Technical Information	Date: 04.06.2018 Official: Marier Department: BT-FIR/MKP3
------------------------------	---

Tech. Information No.	2172 / 2018
Subject:	FPA-5000: new firmware 2.21.2 and RPS 4.10.3 release

Short Description:	<ul style="list-style-type: none"> - New feature: display of detectors 10-digit serial number/ID - Fixed: sporadic FNM-420 trouble - See "new features and "solved issues" below for detailed information
---------------------------	--

1.1. Display printed IDs of detectors in the panel and the RPS software

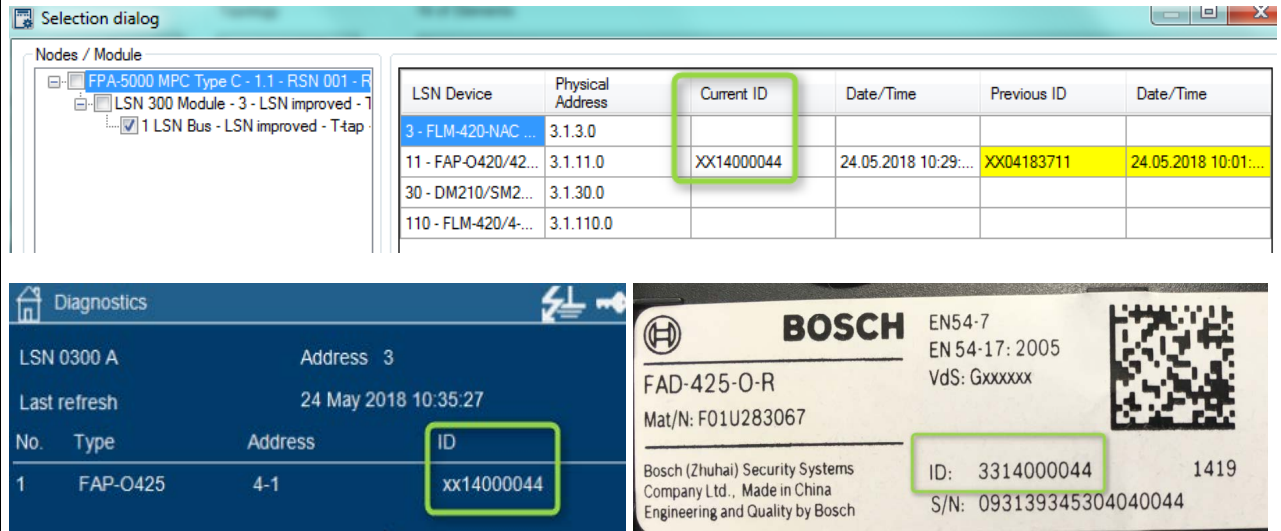
This feature allows to see the identical ID numbers printed on the detector label also in the panel. Detectors which are now identifiable by its 10 digit ID number, the first two digits are replaced by a XX. This applies to elements with the same type-ID but different type-code.

For RPS the first two digits are always represented as XX.
